MONTGOMERY COUNTY HISTORIC PRESERVATION COMMISSION
STAFF REPORT

Address:	5918 Cedar Parkway, Chevy Chase	Meeting Date:	10/9/2024
Resource:	Non-Contributing Resource Chevy Chase Village Historic District	Report Date:	10/2/2024
Applicant:	Rebecca & Rob Nichols (Angela Koloszar, Agent)	Public Notice:	9/25/2024
Review:	1084766	Tax Credit:	n/a
Proposal:	Pergola Construction	Staff:	Dan Bruechert

The applicant proposes to construct a pergola at the rear of the house.

PERGOLA SITE PLAN

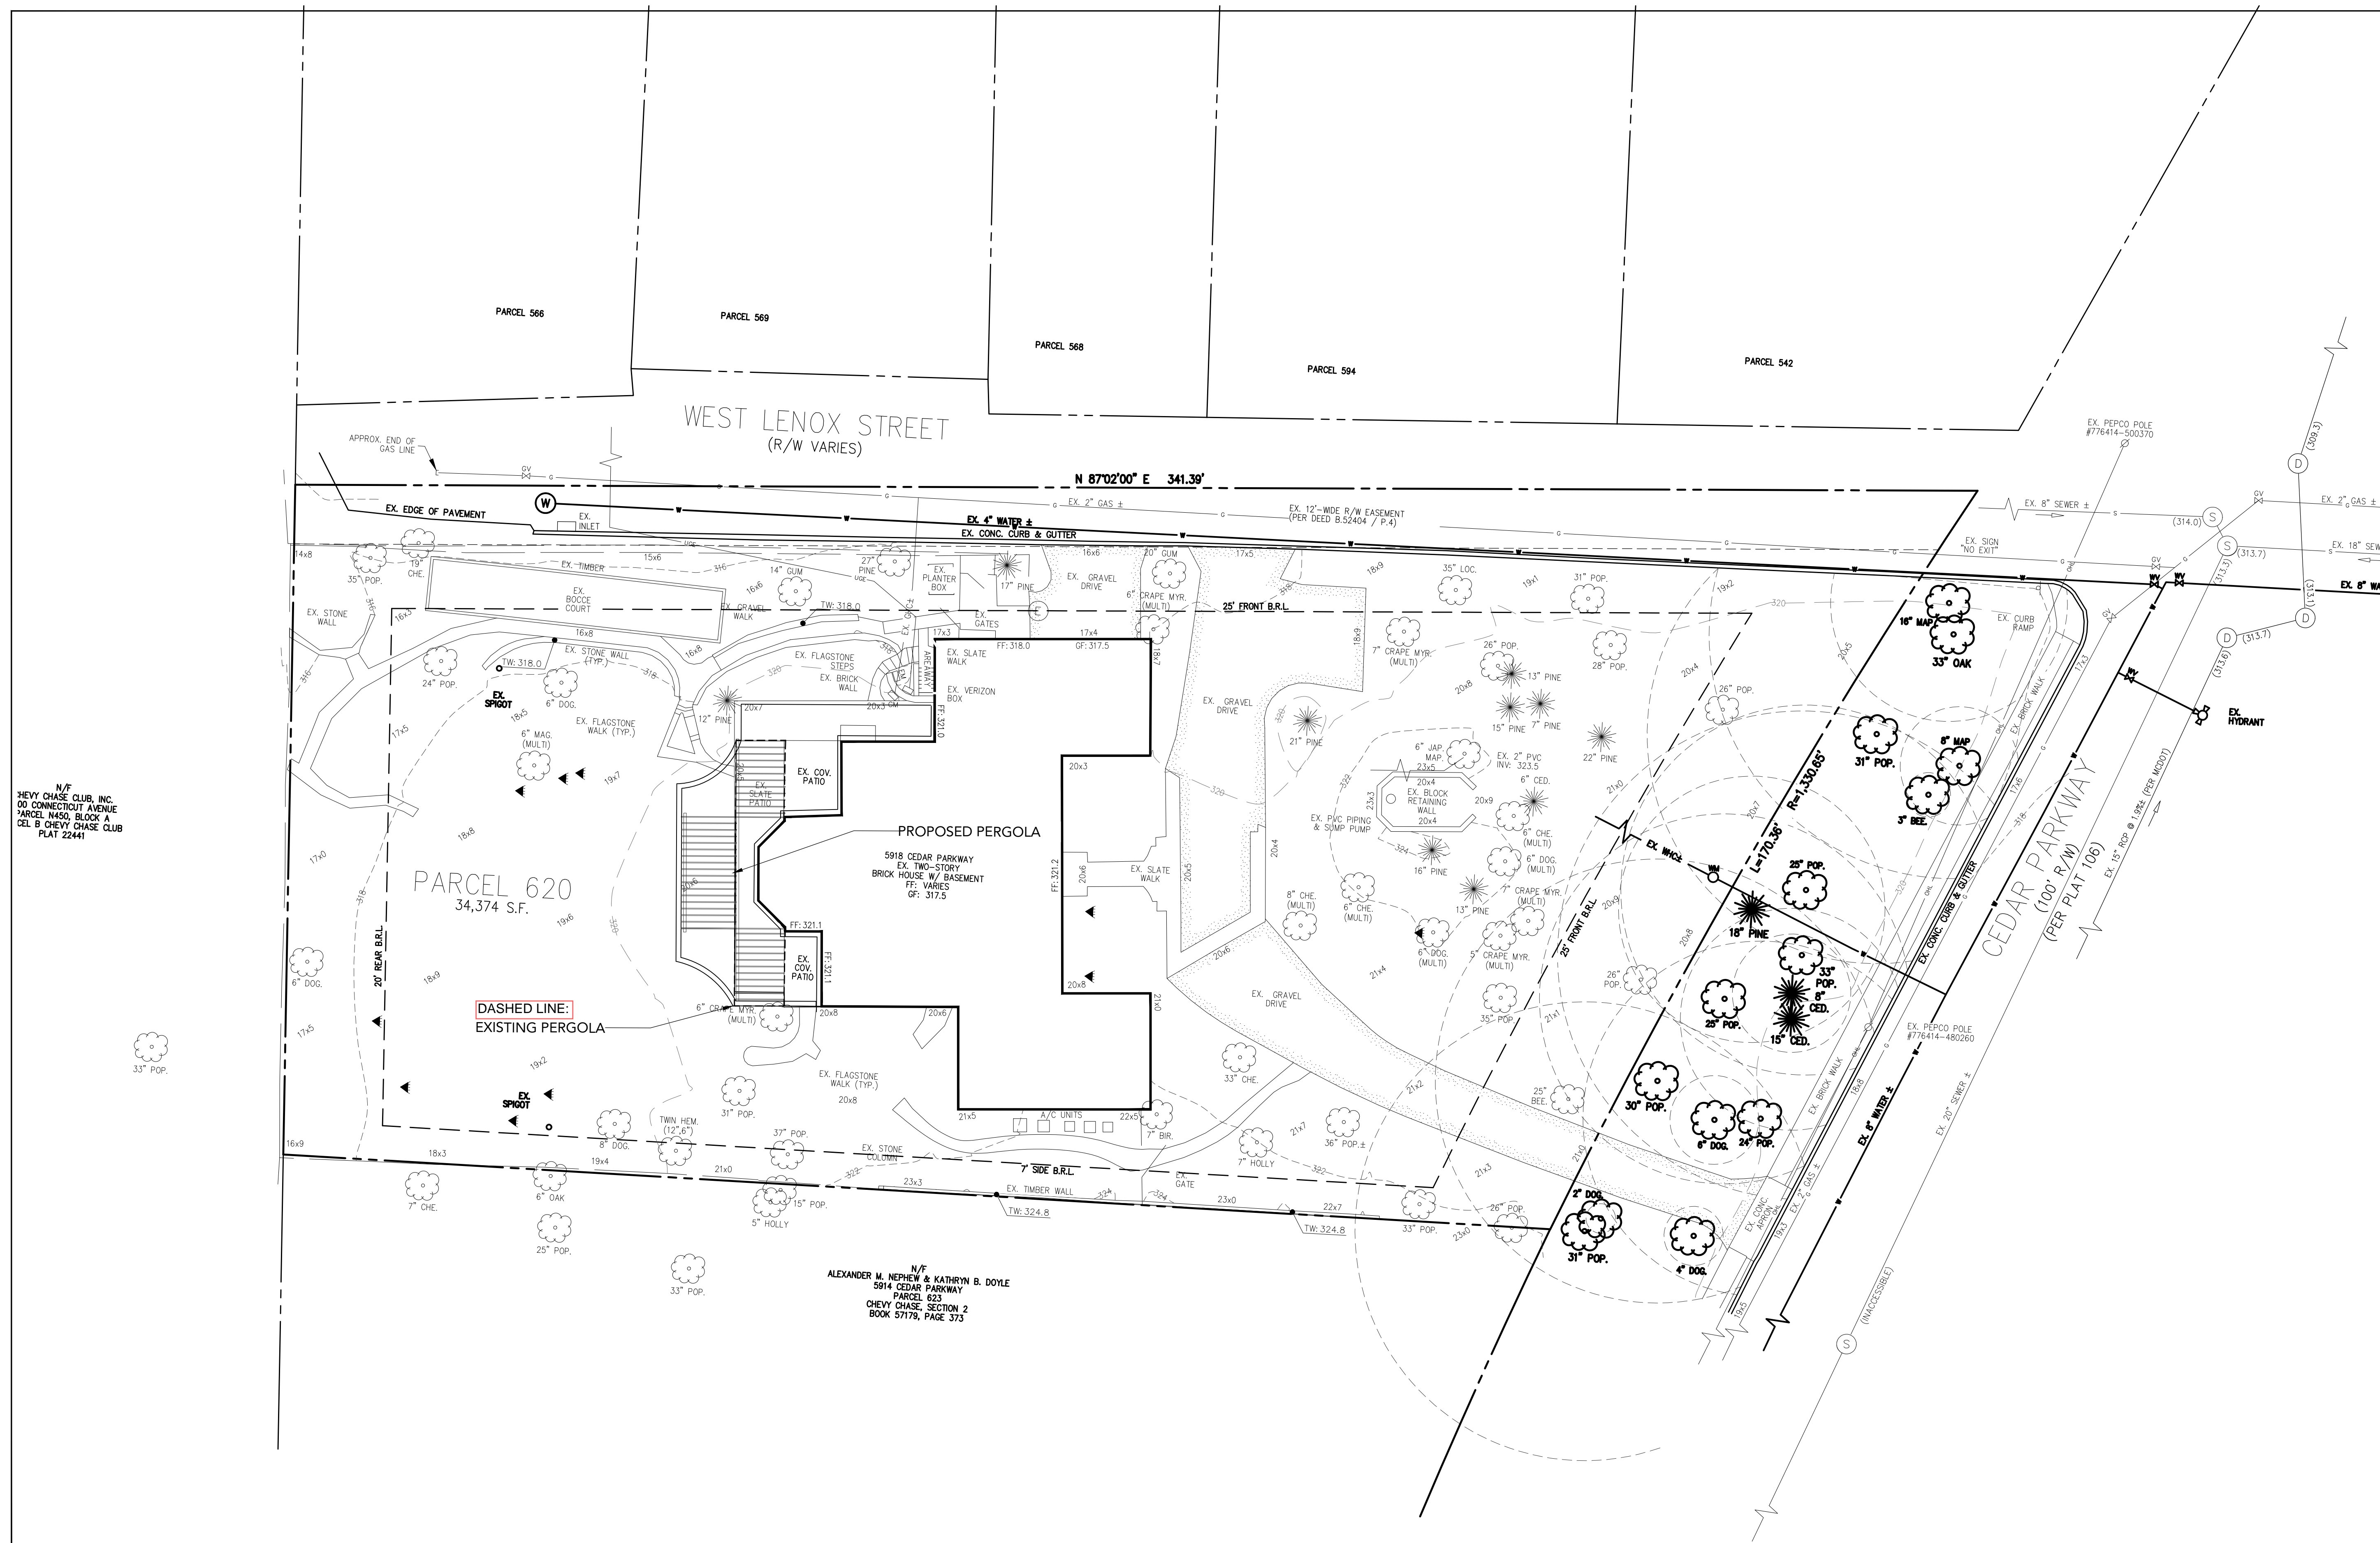
The subject property is a two-story brick house with a U-shaped plan set back a significant distance from the street. The house is accessed from a long gravel driveway that connects Cedar Parkway and Lenox St. At the rear of the house, there is a metal pergola anchored to the brick walls, largely overgrown with greenery. The applicant proposes to construct a new pergola, matching the footprint of the existing. The new pergola will be supported by two brick piers, with steel beams. The applicant proposes to install a ceiling fan in the center of the pergola.

The pergola appears to be an original feature to the house, however, the subject property was constructed in 1976 and is a Non-Contributing Resource. The portion of the house and pergola that could be visible from Lenox St. are obscured by an existing fence. Under a lenient scrutiny review, Staff finds removing the pergola should be approved as a matter of course.

Staff finds the proposed pergola will not overwhelm the rear elevation of the Non-Contributing Resource. Staff additionally finds the design of the pergola, with its brick piers and steel structure is compatible with the character of the Neo-Colonial style house. As it is being constructed on top of an existing patio, there is no increase in lot coverage, making the proposal compatible with the strict scrutiny review for the district. Staff finds the pergola is appropriate for the character of the house and recommends the HPC approve it under 24A-8(d) and the *Design Guidelines, and Standards 2, 9, and 10*.

Staff recommends that the Commission **approve** the HAWP application under the Criteria for Issuance in Chapter 24A-8(b)(2), and (d) having found that the proposal is compatible in character with the district and the purposes of Chapter 24A;
